## ADDENDUM 02 SARACENNIA FIRE STATION

Date: April 23, 2024

Project #: 004.23.001

Project Name: Saracennia Fire Station  
Saracennia Road,  
Moss Point, MS 39562

**SITE JOINTING PLAN AND DETAILS**

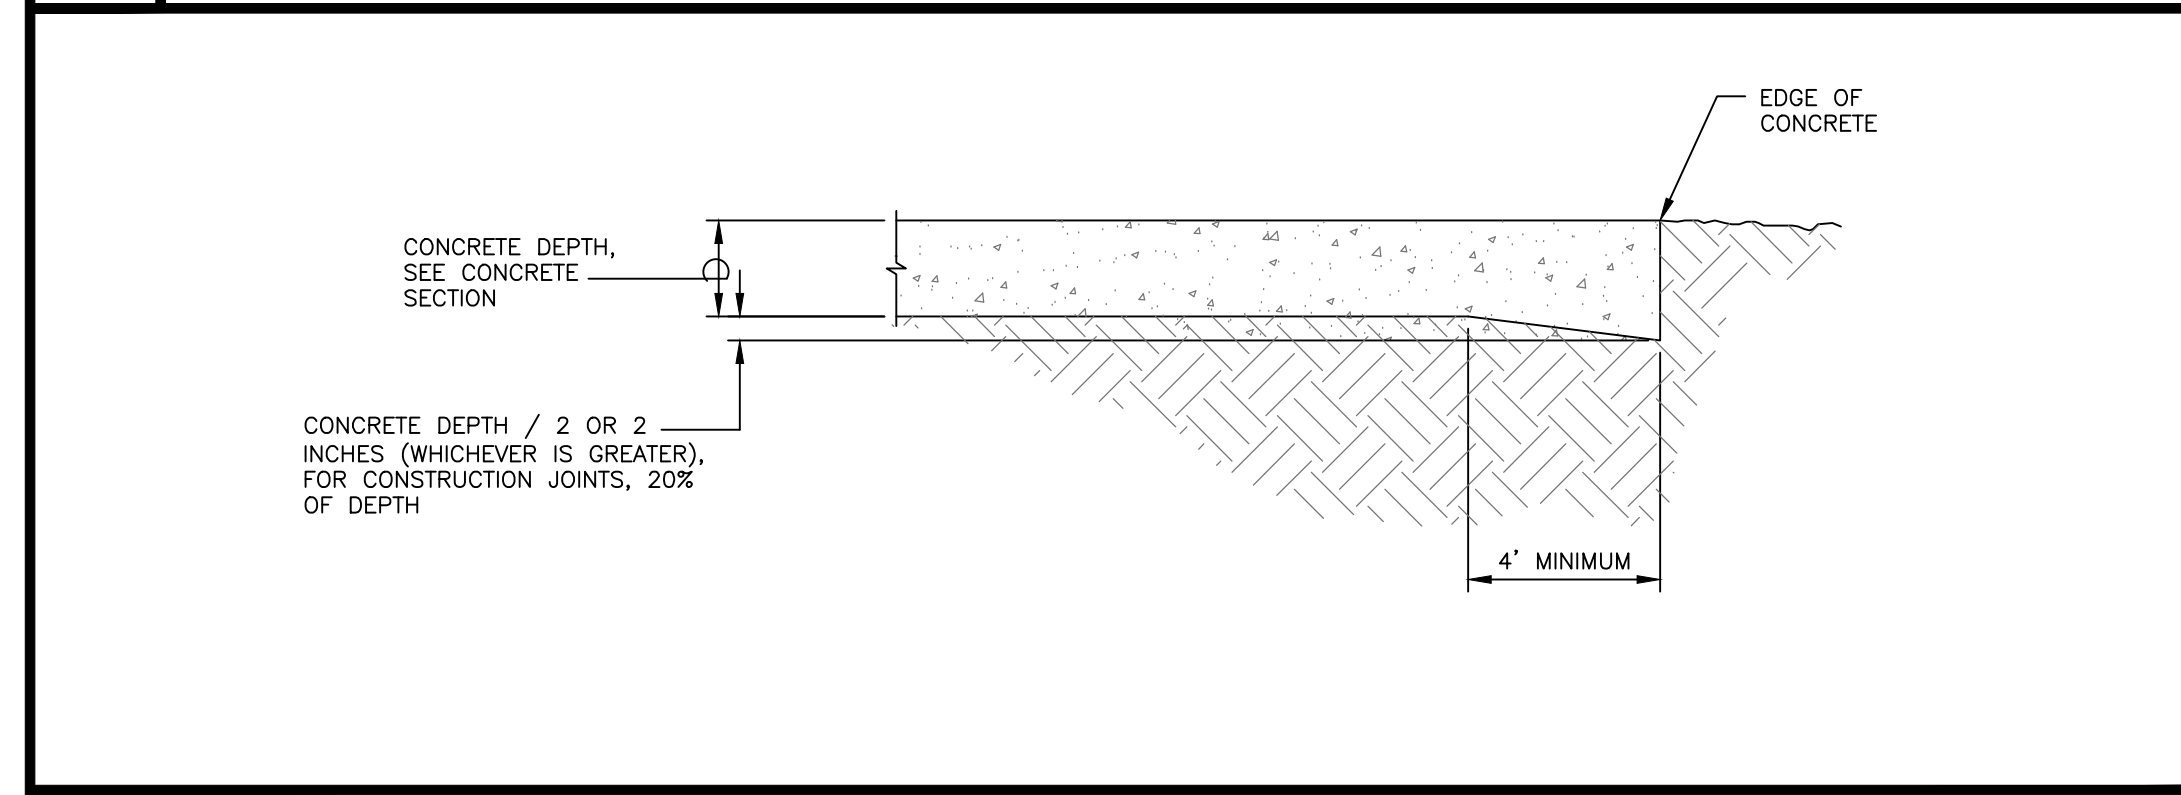
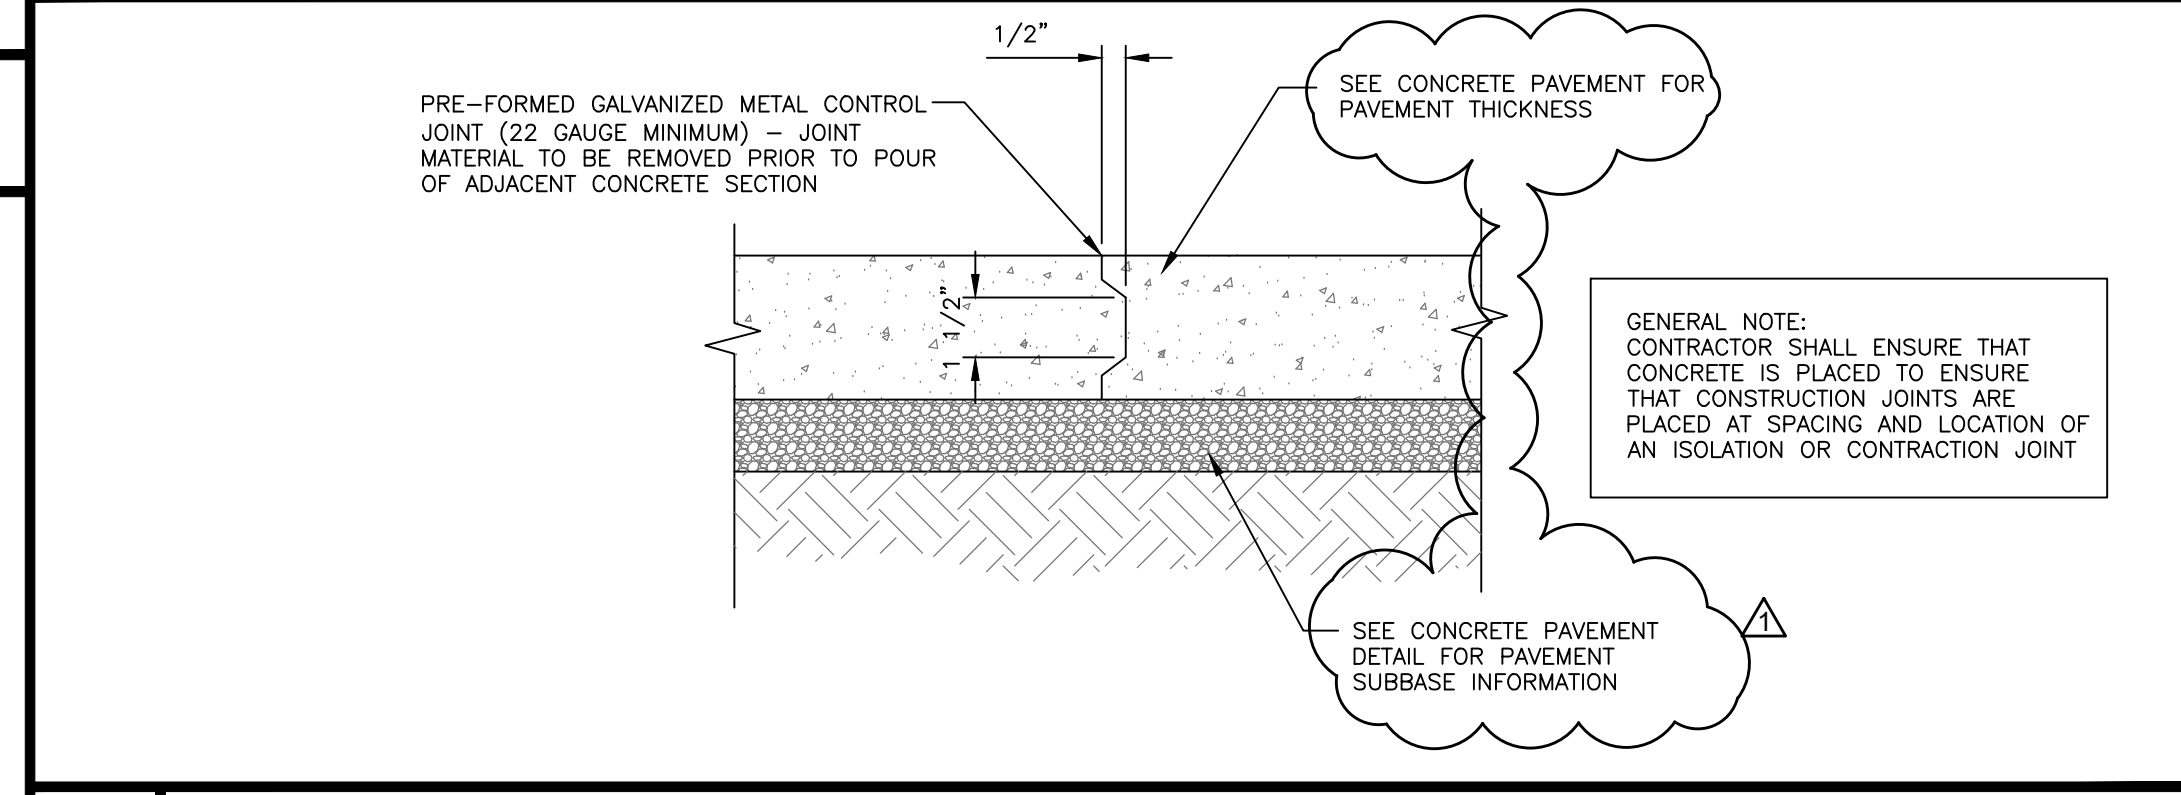
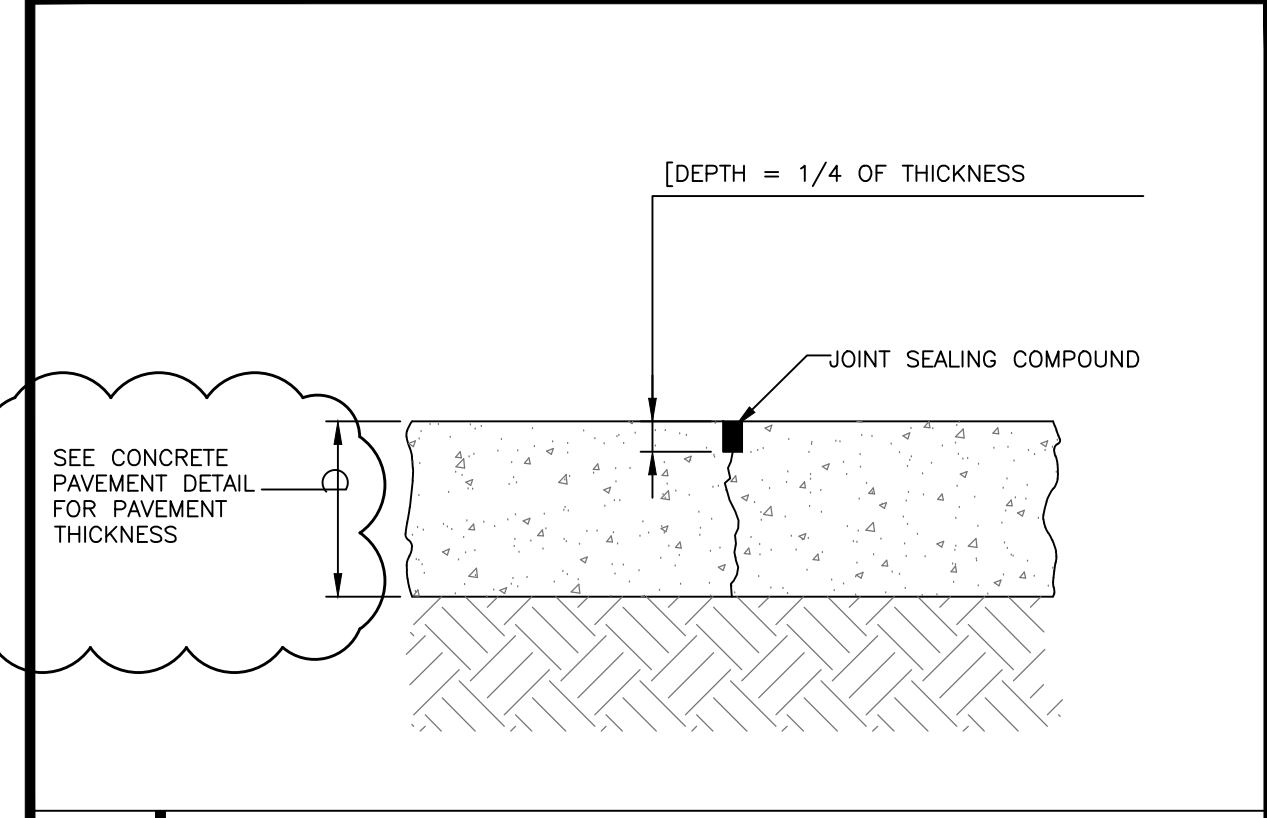
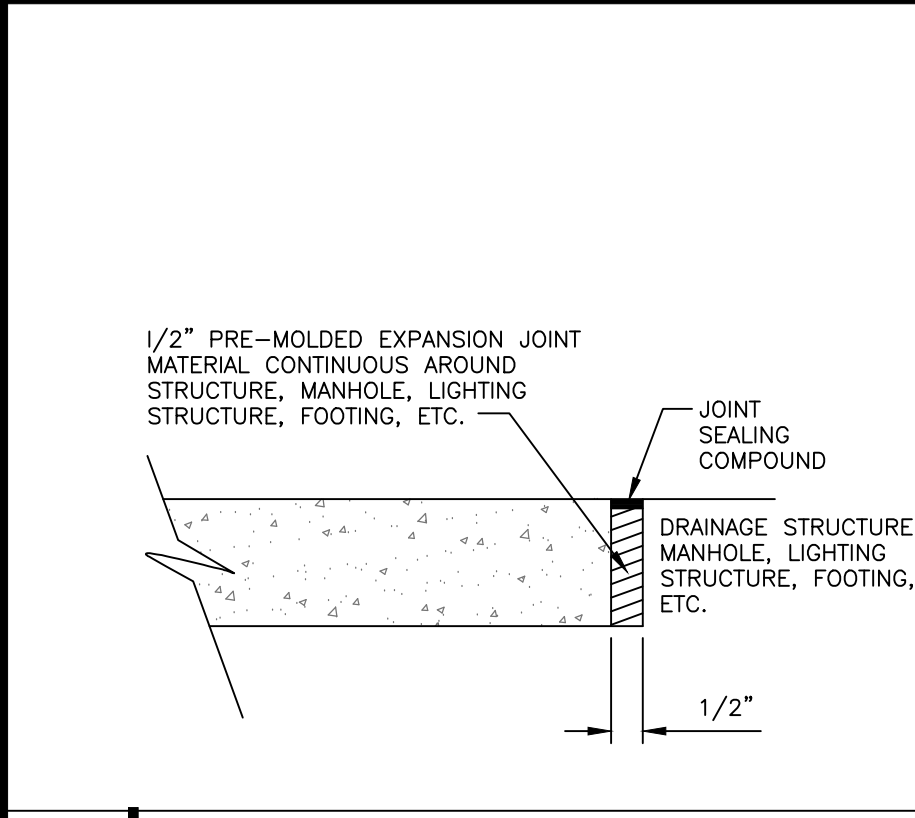
- B5. Will there be any requirement for additional reinforcement in the drive due to the heavy truck traffic? **Revised plan sheet attached including additional reinforcement.**

- C1. C220 – Replace this plan sheet in its entirety
- C2. C620 - Replace this plan sheet in its entirety
